**REMEDIAL ACTION CONSTRUCTION
IMPLEMENTATION – ADDENDUM NO. 1
REPAIR OF SHORELINE EROSION**

**GRATWICK-RIVERSIDE PARK SITE
NORTH TONAWANDA, NEW YORK**

MARCH 2005

REF. NO. 7987 (31)

SHORELINE PROTECTION/SEDIMENT
REMEDATION - SHEET 2 OF 3

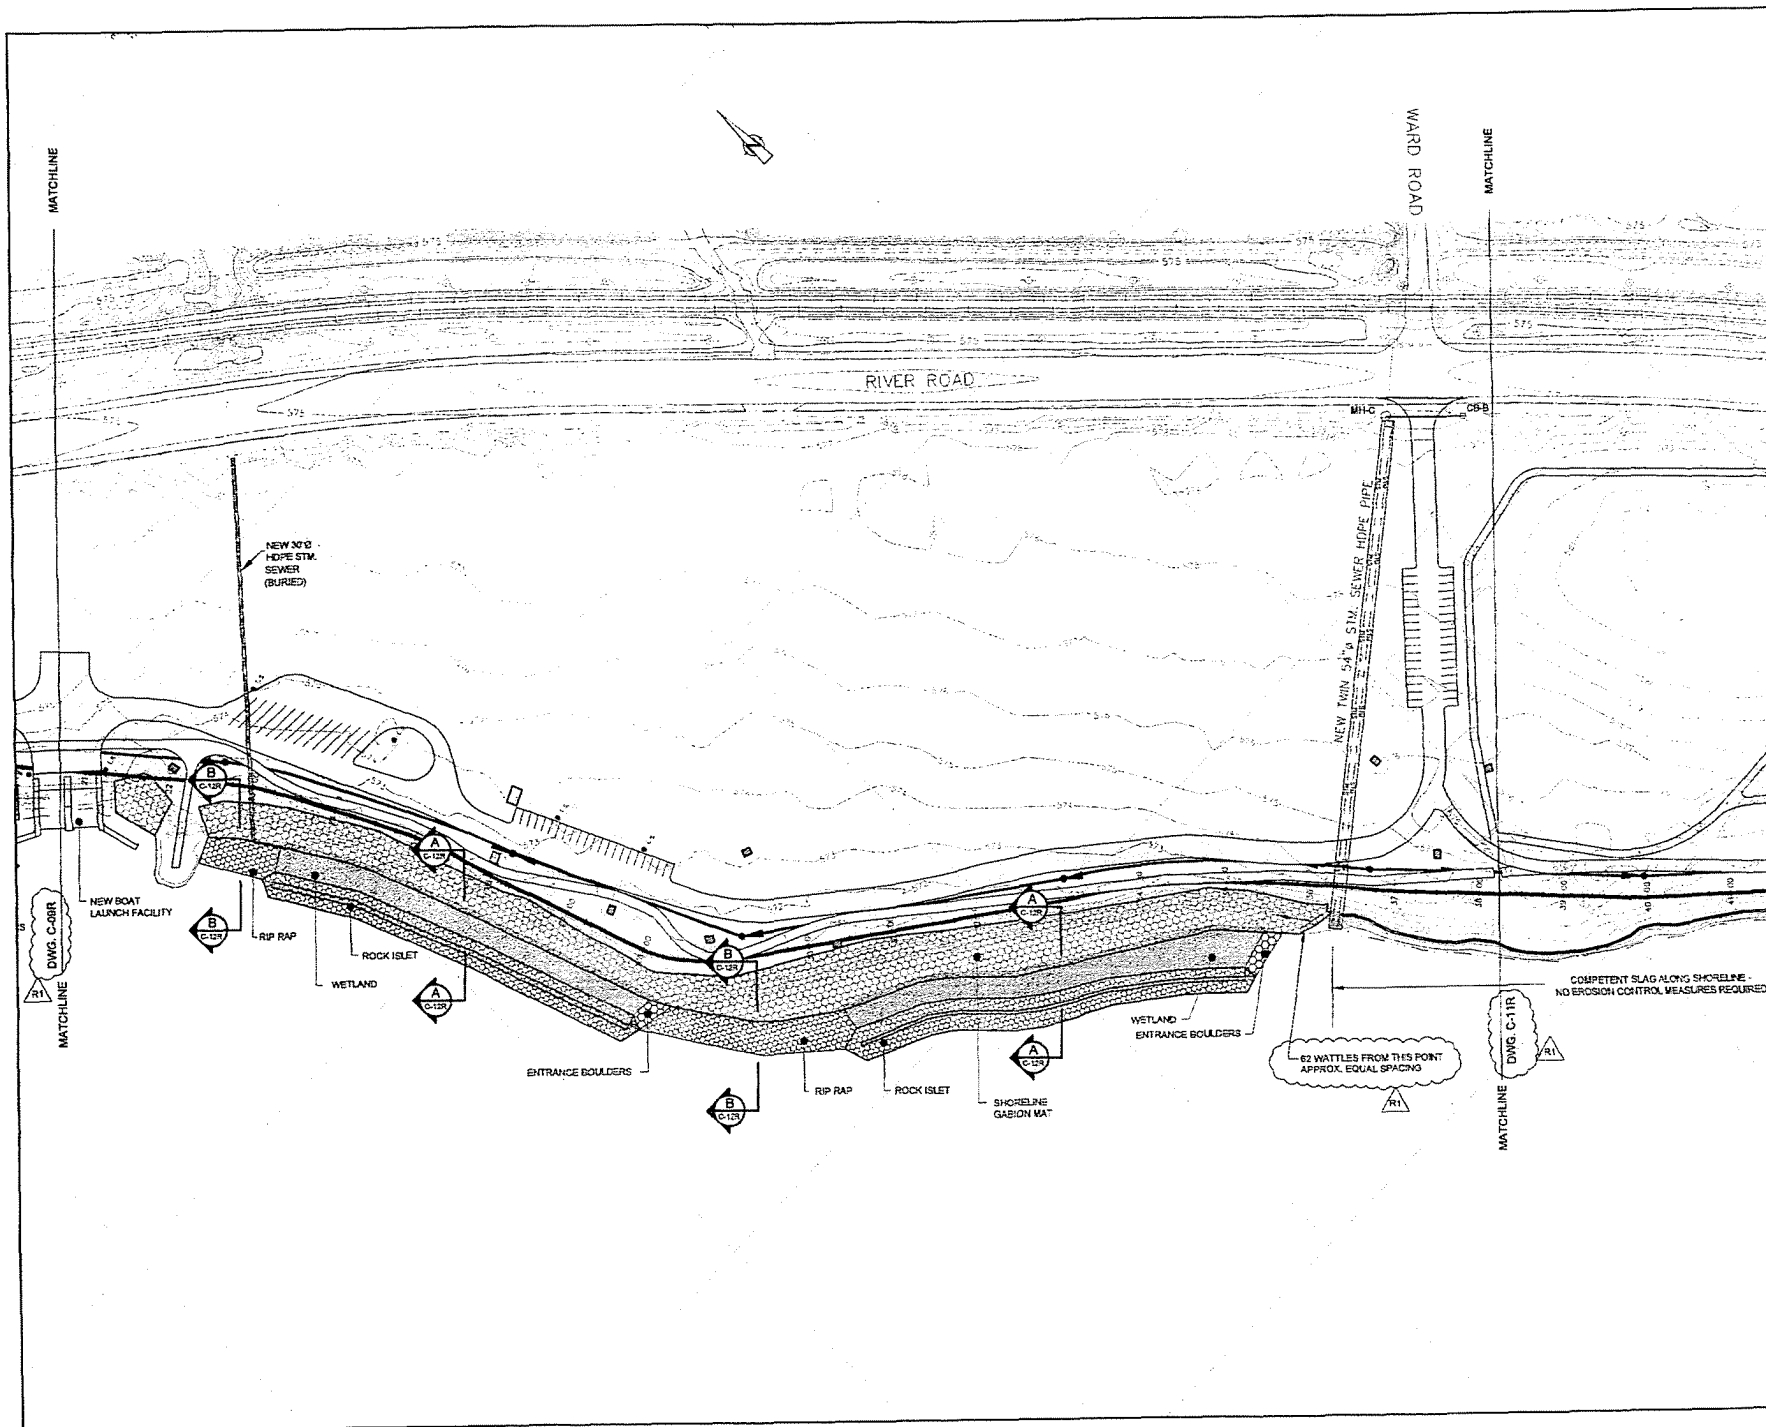
NO	Revised	Date	Label
R1	ADDED SHORELINE REPAIR DETAILS	JAN 19/99	KDS

This drawing is issued by CRA Infrastructure & Engineering, Inc. to indicate proposed changes (identified by encircling) based on the NYSDOT approved design documents and approved subsequent modifications.

SHORELINE PROTECTION/SEDIMENT REMEDIATION - SECTIONS & DETAILS

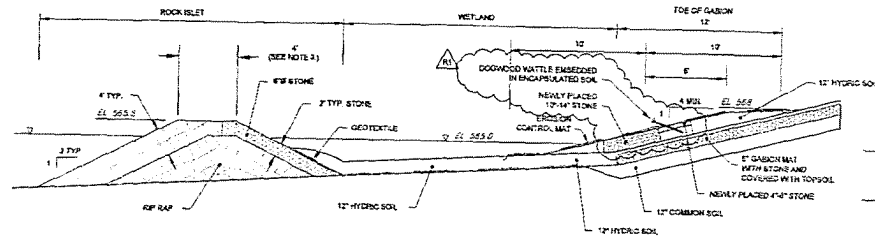
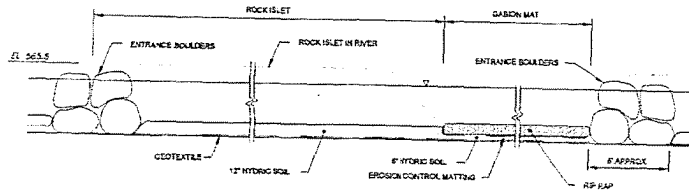
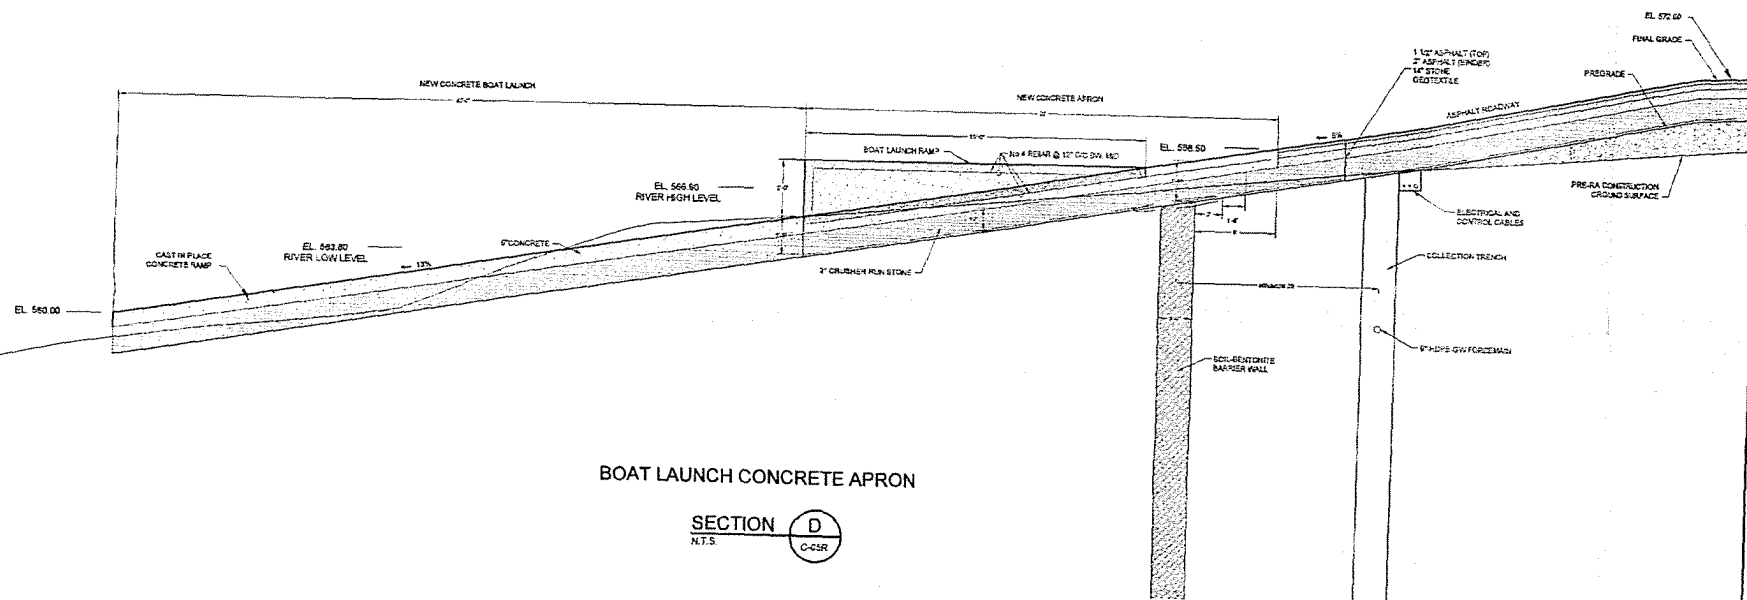
NO.	REVISION	DATE	BY
01	ADDED SHORELINE REPAIR DETAILS	JAN. 1983	KCS
